STAFF REPORT

FROM: André Boel, Director of Planning **FILE NO:** 3220-20 Gower 377-385
Odete Pinho, Planning Consultant DP-2013-01

SUBJECT: Development Permit Area No. 5 Form and Character (DP-2013-01) for George Hotel and Residences

Figure 2: Hotel south elevation showing variation in material and landscape elements (drawing A9.0.1)

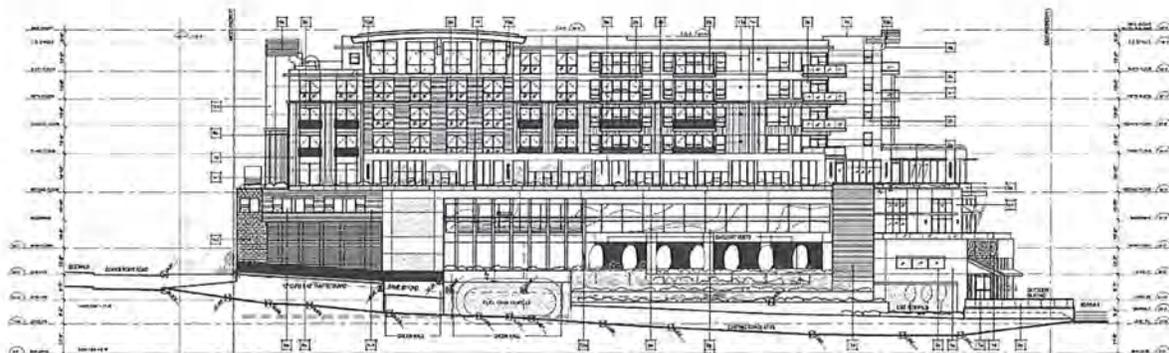
The building façades step back from adjacent public areas (Gower Point Road, Winegarden Park, future waterfront walkway). A more detailed evaluation was provided in the staff report dated March 25, 2014. The combination of different colours and materials on the buildings exterior facades, creates visual interest and breaks up the mass of the building. The building design uses the following materials with warm tan, brown, grey and blue/green accent colours:

Figure 3: View of waterfront restaurant south elevation (drawing A9.0.6)

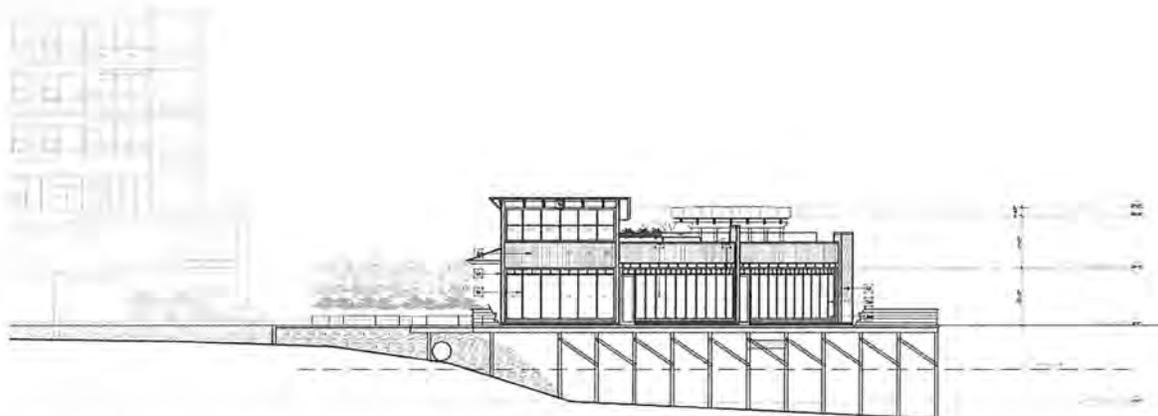
The waterfront restaurant is to use fibreboard cement, cedar coloured shakes, and metal cladding. The pier main deck has guards with a mixture of wood, glass and steel cables to evoke a marine spirit. These materials fit in the existing Gibsons' waterfront marine context. The structure for the pier requires environmental and structural reviews prior to final selection of materials. If it is determined that the pier needs to be concrete for environmental and structural reasons, the colour will be such that it suits the surrounding area and be integrally coloured rather than painted.

Figure 7. Gower Point Road streetscape (drawing A9.0.3a)

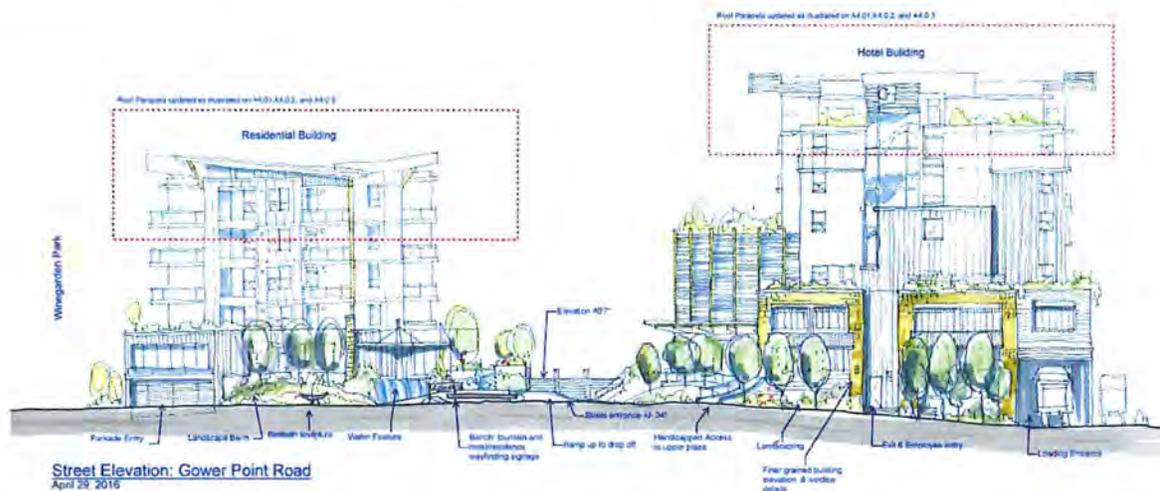
The landscape design includes pebbled paving, use of rock and plantings, seating (see also L1, L2, L3, L4, L5). At the waterfront the design includes a clock structure at the base of the stairs. The Gower Point Road façade has been updated in 2014 following APC recommendations. More recently, following the results of the geotechnical review, the façade was updated to reflect an increase elevation of the level of the Plaza. From Gower Point Road the Plaza is now approximately 1.80m (6 ft) higher. Although some individuals will not be able to look over the Plaza from Gower Point Road this is a necessary change in order to protect the Gibsons Aquifer.

Figure 9: Cross section showing waterfront walkway and adjacent uses (drawing A9.0.3c)

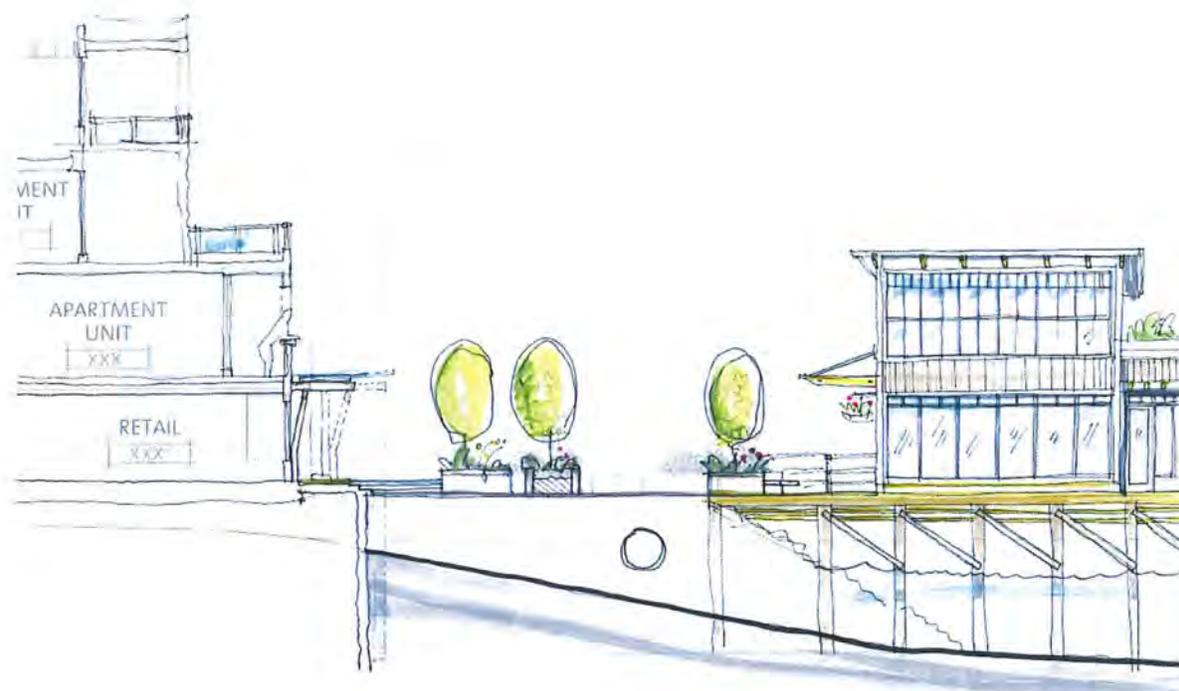
The pedestrian walkway is located through the centre of the site, which maintains and improves the current access through Winn Road. Along the waterfront new access is provided by the proposed walkway and pier. The waterfront walkway would solve a key missing link in the envisioned waterfront walkway. A seawalk café, retail space, and the restaurant on the pier provide a range of uses as possible pedestrian destinations. Landscape elements, water features, consistent concrete surfacing and wood elements at the waterfront are combined to create a diverse and attractive pedestrian environment. See also under *Streetscape*.
